### COMMITTEE OF ADJUSTMENT STAFF REPORT

**RE:** Minor Variance Application

152 William Graham Drive Plan 65M4433 LOT 63

File: MV-2020-24

SITE PLAN

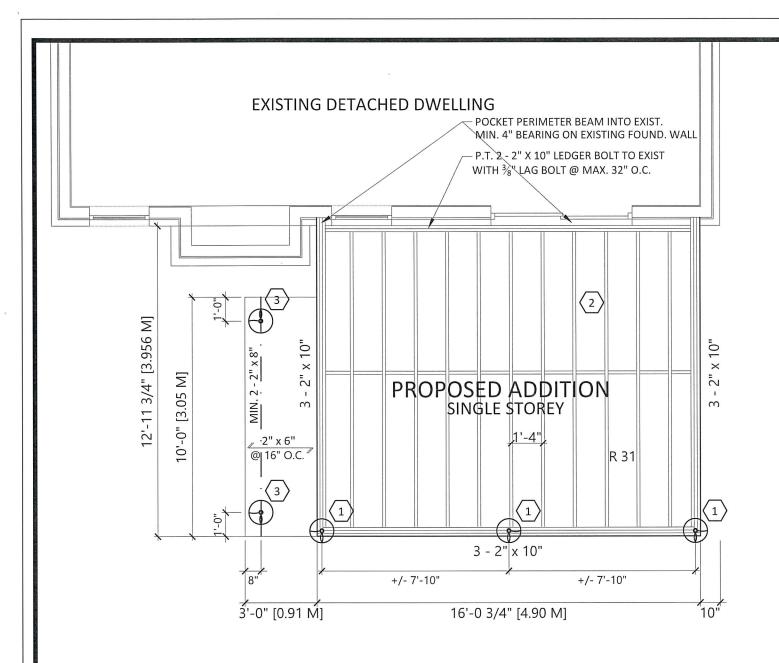
a) Section 24.408.2.2 allows a minimum rear yard of 7.0 metres for additions. The applicant is proposing a one-storey sunroom addition with a rear yard setback of 4.5 metres.

The applicant originally requested a rear yard setback of 3.92 m (13.0 ft) but worked with staff to revise the proposal to increase the setback to 4.5 m (15.0 ft).

The property located south of the subject lands at 156 William Graham Drive contains a two-storey single-detached dwelling and the proposed addition will be constructed next to the mutual side property line. Staff do not anticipate any impacts as an interior side yard setback of 1.26 m (4.13 ft) - 1.46 m (4.79 ft) will be provided on the subject lands, in addition to the existing side yard setback for the adjacent property to the south. Staff also note that the portion of the addition facing the south interior property line does not include windows which will help to maintain privacy.

The property adjacent to the subject lands to the west (406 Hartwell Way) contains a twostorey single-detached dwelling. Although the addition would be constructed closer to the rear yard property line than what the by-law allows, staff are of the opinion that the new requested variance of 4.5 m (15.0 ft) will not result in any conflicts as it relates to building separation nor will it impact the enjoyment of the rear yard amenity areas with either of the adjacent neighbouring properties as both the side and rear yard setbacks provided are sufficient.

side yard setback requirements are still being met and when considering the building setbacks of abutting properties, staff do not anticipate any impacts. The applicant has worked with staff to revise the rear yard setback originally requested resulting in an increased setback of 4.5 m (15.0 ft) from the rear yard property line which is sufficient in the opinion of staff.

Staff are of the opinion that the proposed rear yard setback of 4.5 m (15.0 ft) provides adequate amenity space within the rear yard. Given the existing building location of the dwellings on the subject and adjacent properties, staff are of the opinion that the rear yard setback proposed is sufficient to accommodate the proposed modest building addition.

- 1. That the variance only applies to the subject property, in substantial conformity with the plan(s) attached as 'Appendix B' to this Staff Report which are dated October 17<sup>th</sup>, 2020 and PZR stamped December 4, 2020, with respect to the location of the addition, to the satisfaction of the Director of Planning and Development Services or designate.
- 2. That the Owner shall pay all development fees to the LSRCA in accordance with the approved Fees Policy under the *Conservation Authorities Act* (Note: Under the 2019 LSRCA Fee Policy, this amount is \$500.00).
- 3. That the Owner shall obtain a permit under Ontario Regulation 179/06 prior to the proposed development and site alteration taking place.
